Generally located 1/4 mile west of N. Black Cat Rd. and north of W. Chinden Blvd., in the South 1/2 of Section 21, T.4N., R.1W.

Final plat consisting of 62 buildable lots and 17 common/other lots on 9.31 acres of land in the R-8 and R-15 zoning districts for the first phase of Pollard North Subdivision.

E. Common Driveway Exhibit

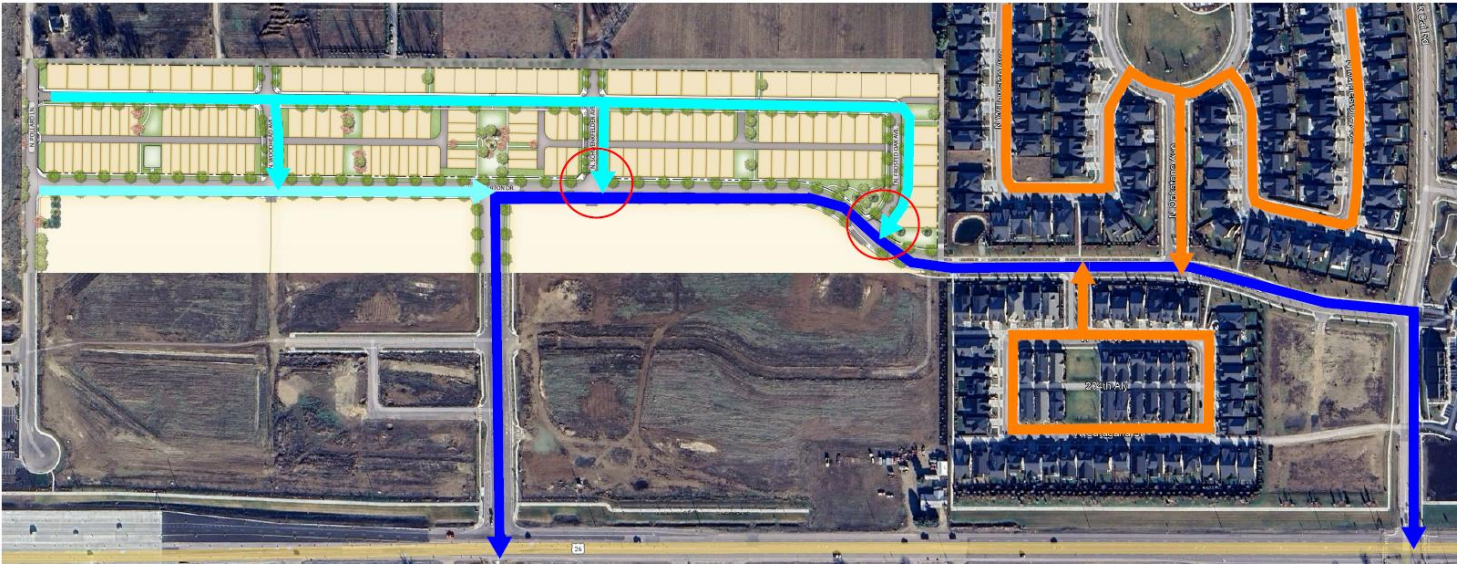
6. The common driveway on Lot 16, Block 1 shall comply with the standards listed in UDC 11-6C-3D and the setback exhibit above in Section VII.E.
7. The subject property shall be subdivided prior to submittal of any building permit applications for development as set forth in the development agreement.
